METROPOLITAN AREA PLANNING
DEPARTMENT

Re: S/D 92-34 - SOUTHERN KANSAS TELEPHONE 2nd ADDITION
(Final Plat)

STAFF REPORT
(Final Plat Approved 8/6/92)

CASE NUMBER: S/D 92-34 - SOUTHERN KANSAS TELEPHONE 2ND ADDITION

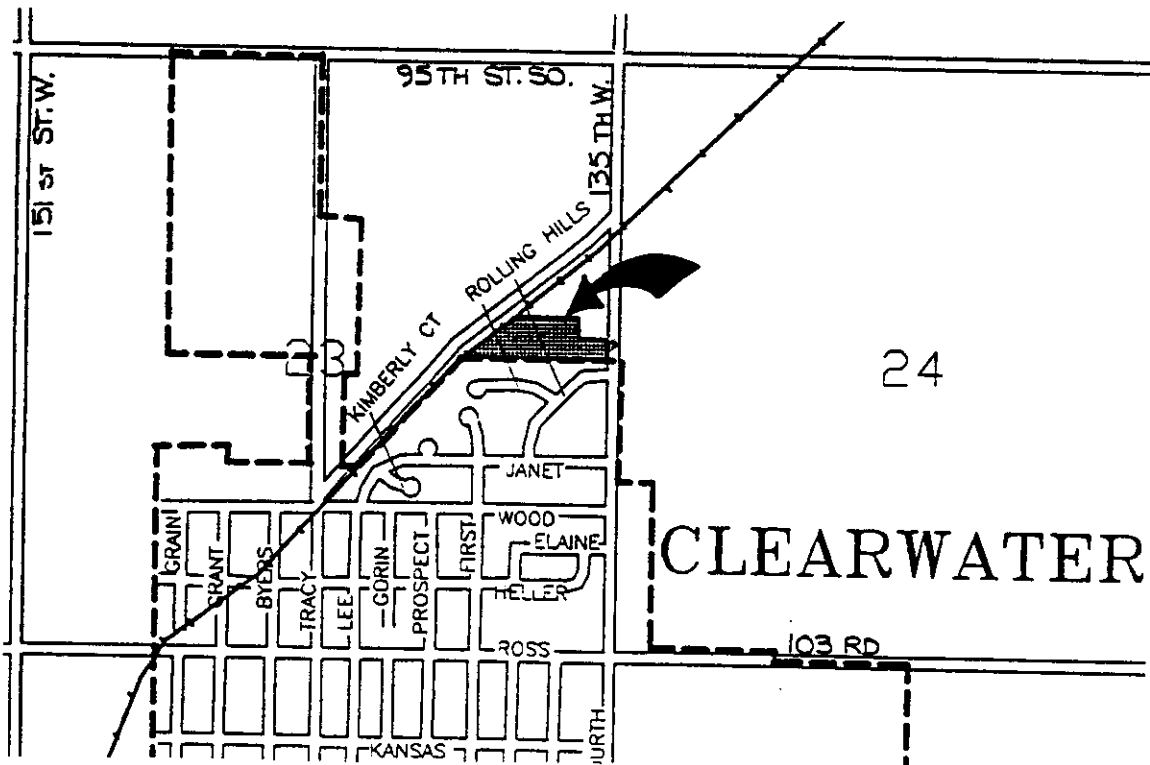
- A. Since Clearwater's sanitary sewer and water facilities are adjacent or reasonably available for use by this site, the applicant shall make arrangements with Clearwater for the extension of sanitary sewer and municipal water to this Addition. A letter shall be submitted, from the City of Clearwater, indicating that such satisfactory arrangements have been made.

- B. The applicant shall guarantee any drainage improvements required by the platting of this property.
- C. If any of the site's drainage is to the railroad right-of-way to the west of the plat, a letter shall be provided from the railroad (Mo. & Pac.) indicating their willingness to receive such drainage.

- E. The setback along the south line of this plat is appropriate and is being provided to create a buffer between this site and the residential area immediately to the south.

- F. With regard to the access control shown for this site to 135th Street West, the following changes shall be made on the final plat tracing:
 - 1. The word "complete" should be deleted from the face of the plat since an opening is being allowed.

- 2. The plattor's text should note that access control, except for 1-opening is being dedicated to 135th Street West across this site's east line. The text is now implying that complete access control is being dedicated.
